# Access Compliance Report Public Rights-of-Way (Curb Ramps)

Intersection ID: 10862	Main Street: N_GRAHAM_ST	Cross Street: DALTON_AV	Location: NW
ADA ID: 8DA28E0884E7	Ramp Type: Perp	Initial Pass/Fail: Fail	Overall Compliance: No
<b>Codes/Mitigation Info/Possible Solution</b>			<b>Field Measurements/Component Compliance</b>

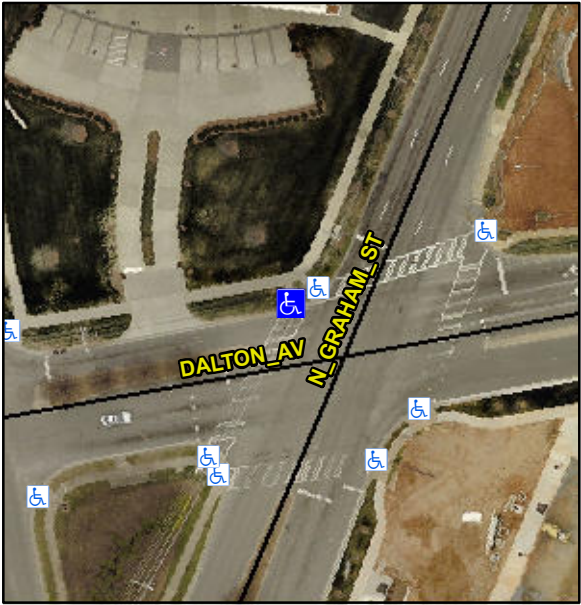
PROW/ADA:  
**Not Found, R304.5.1**

Compliance	Description	Data	Compliance	Description	Data
N/A	Ramp Length (in)	143.0	Yes	Ramp Slope (%)	6.0
No	Ramp Width (in)	47.5	Yes	Ramp XSlope (%)	3.0
N/A	Flare Type LT	N/A	N/A	Flare Type RT	N/A
N/A	Flare Slope LT (%)	N/A	N/A	Flare Slope RT (%)	N/A
N/A	Flare Traversable LT?	N/A	N/A	Flare Traversable RT?	N/A
N/A	Landing Length (in)	N/A	N/A	DWS Provided?	N/A
N/A	Landing Width (in)	N/A	N/A	DWS Contrast?	N/A
N/A	Landing Slope (%)	N/A	N/A	DWS Length (in)	N/A
N/A	Landing X Slope (%)	N/A	N/A	DWS Full Width?	N/A
N/A	Landing Curb? (Y/N)	N/A	N/A	DWS Offset (in)	N/A
N/A	Shared Landing?	N/A			
N/A	Gutter Ponding?	N/A	N/A	Gutter Slope (%)	N/A
N/A	Gutter Lip Ht (in)	N/A	N/A	Gutter X Slope (%)	N/A
N/A	Painted X Walk1?	Yes	N/A	Painted X Walk2?	N/A
	X Walk 1 Direction	To SW		X Walk 2 Direction	N/A
N/A	X Walk 1 Width (in)	140.0	N/A	X Walk 2 Width (in)	N/A
	X Walk 1 Slope (%)	0.3		X Walk 2 Slope (%)	N/A
	X Walk 1 X Slope (%)	4.9		X Walk 2 X Slope (%)	N/A

Possible Solutions:  
**Remove & Replace Entire Ramp.**
